FIRE SPRINKLER

RESIDENTIAL FIRE PROTECTION SYSTEM

CUI AND LIU RESIDENCE
 8636 N. MERCER WAY
 MERCER ISLAND, WA 98040

1
 F100 LOWER FLOOR
 1/4" = 1'-0"

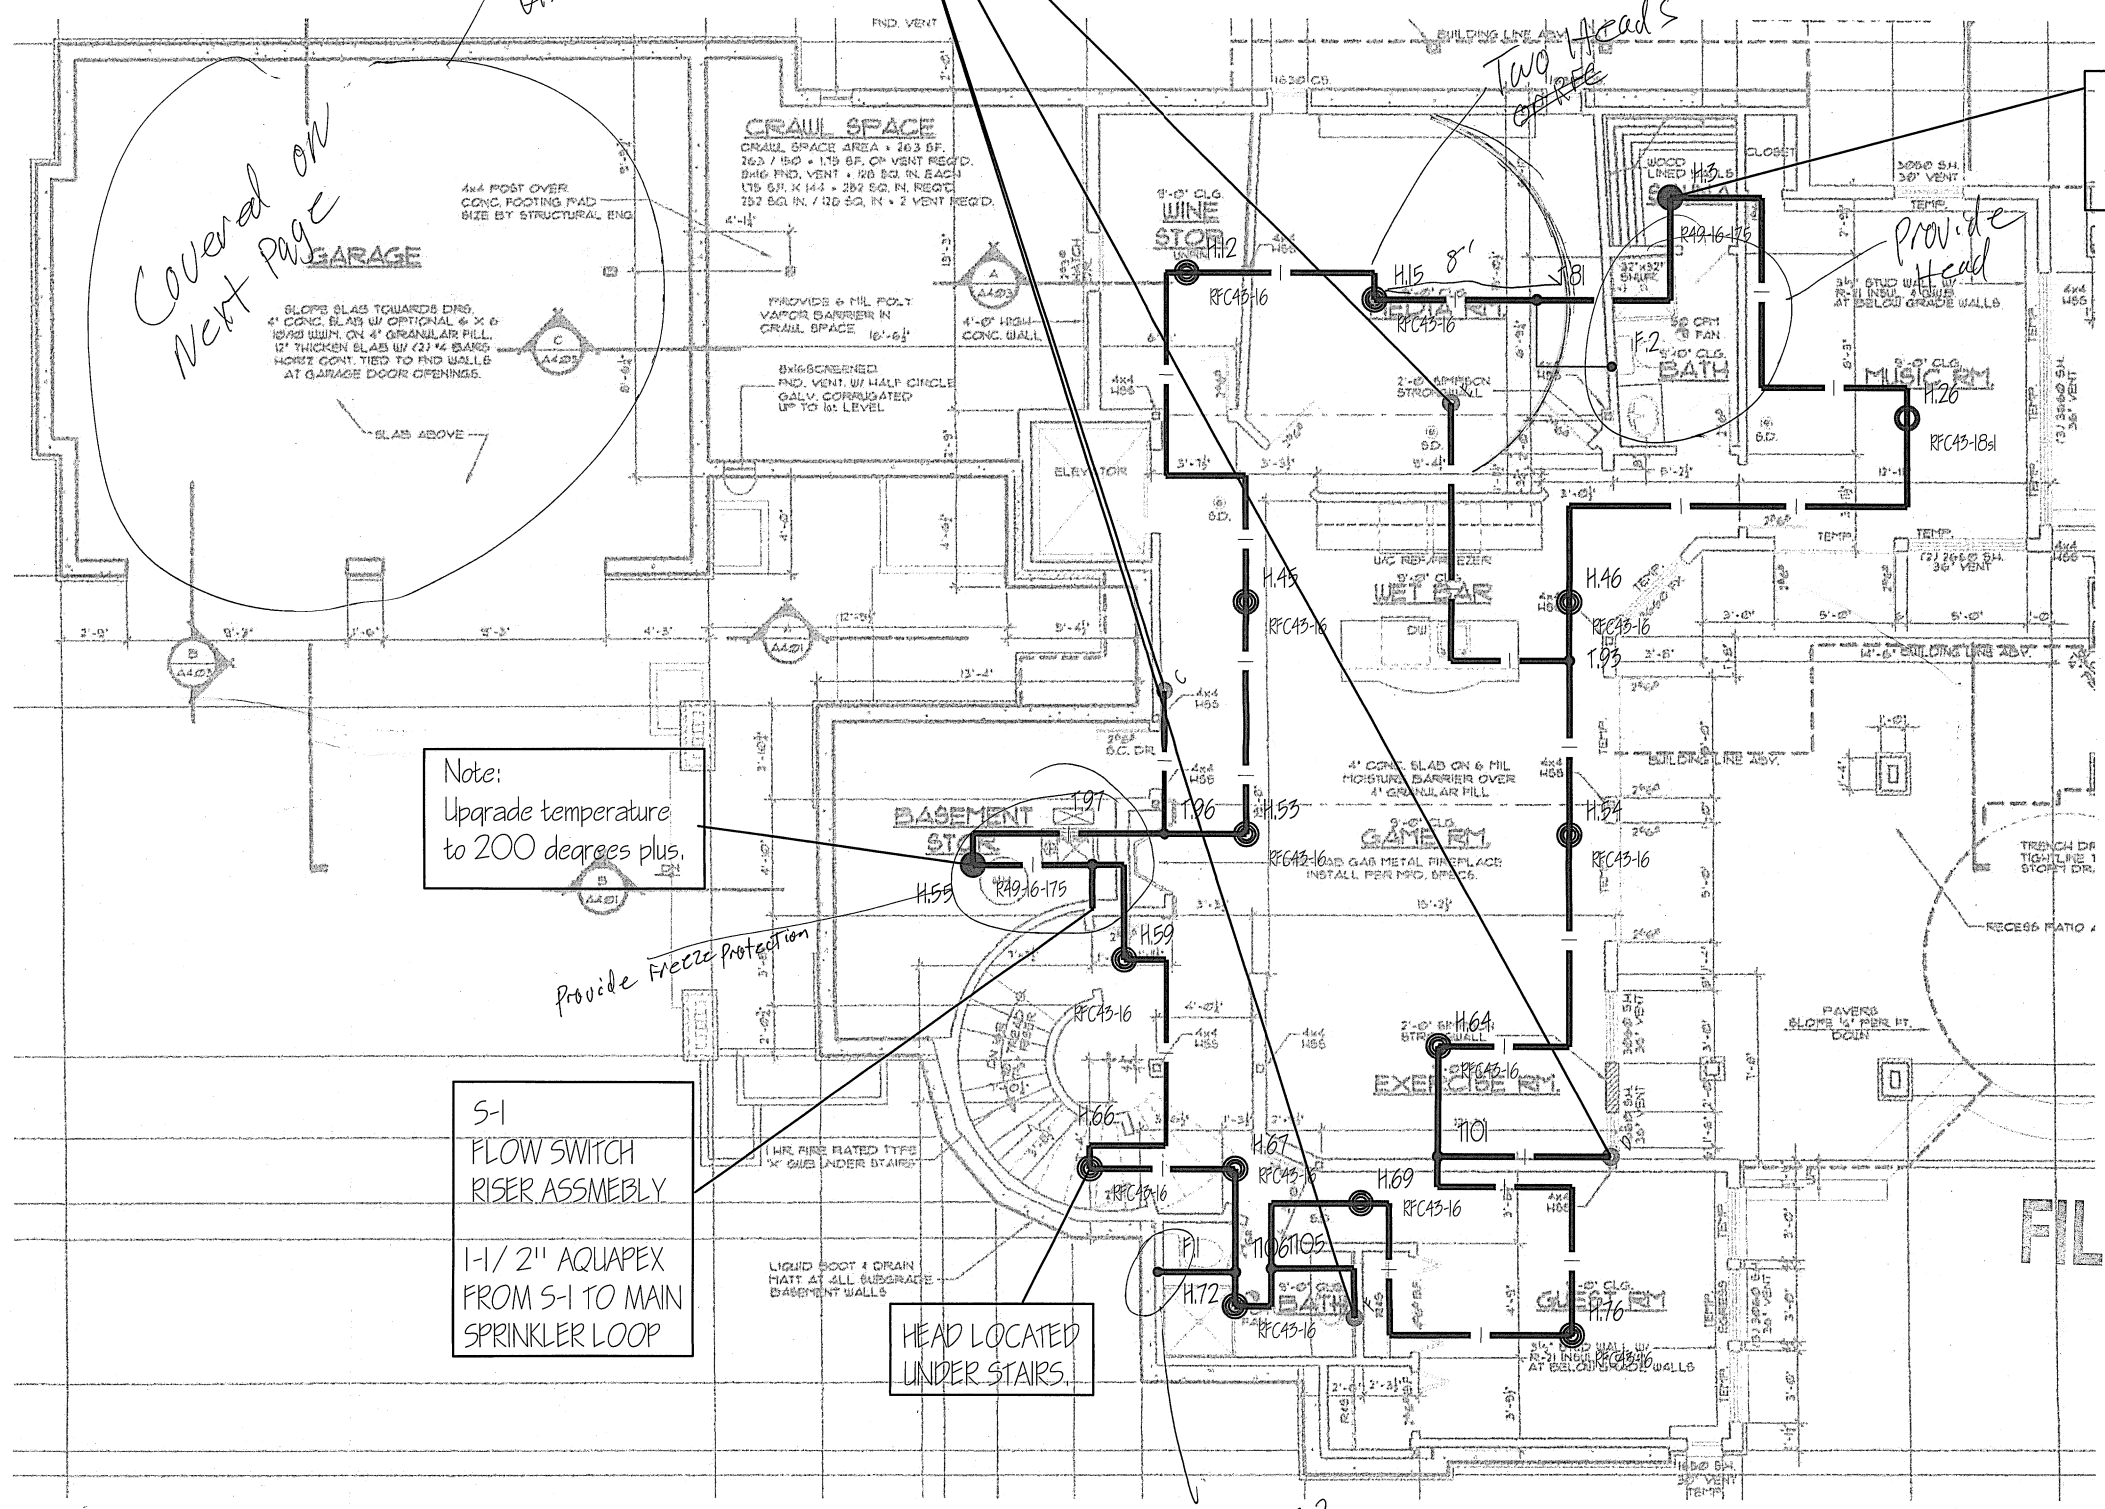
Note:
 Upgrade temperature
 to 200 degrees plus.

Note:
 Upgrade temperature
 to 200 degrees plus.

Provide Freeze Protection

What is this?

1 MAIN FLOOR
 F100 1/4" = 1'-0"

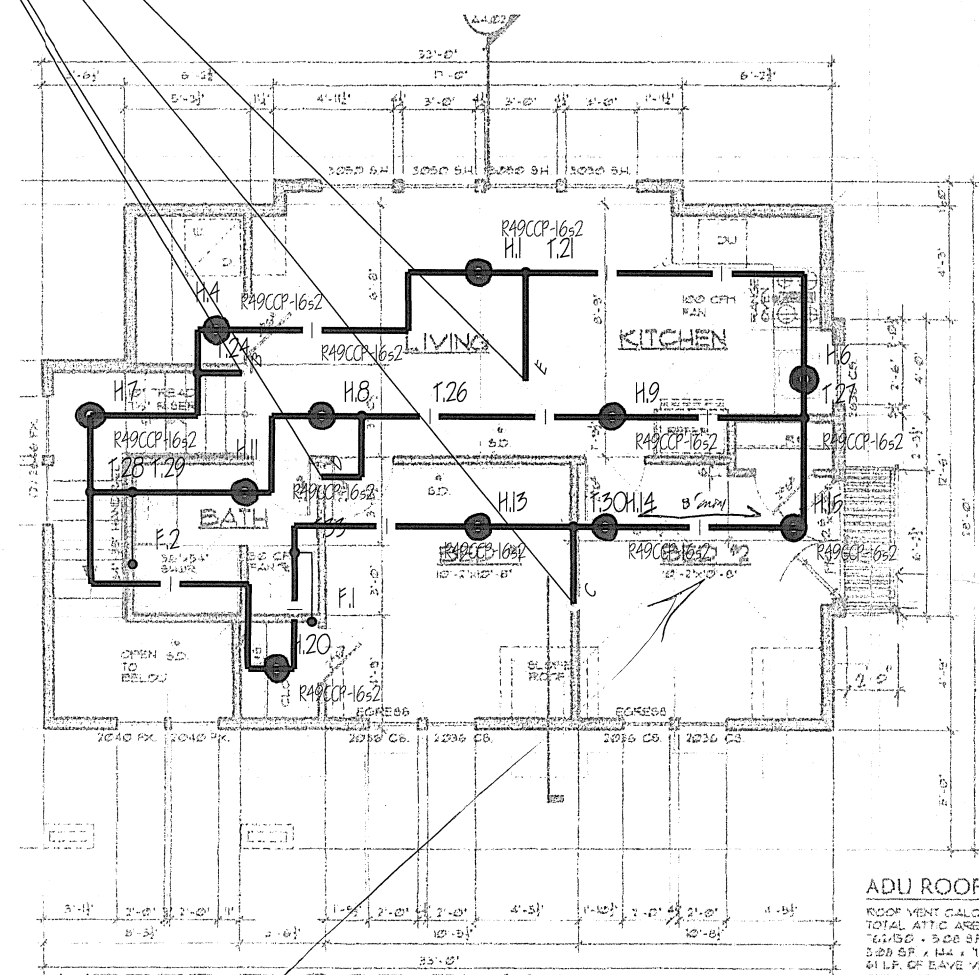
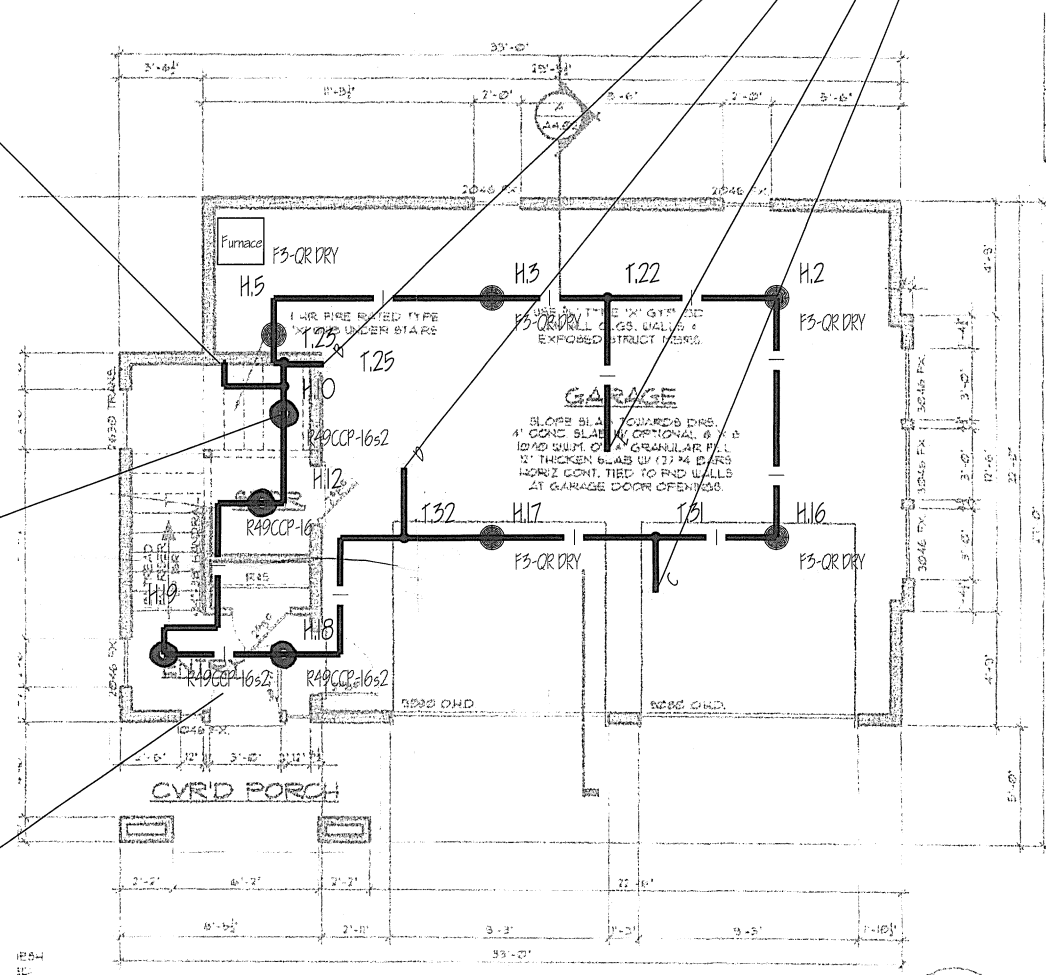
Verify Heads meet requirements for sloped ceilings & obstructions?
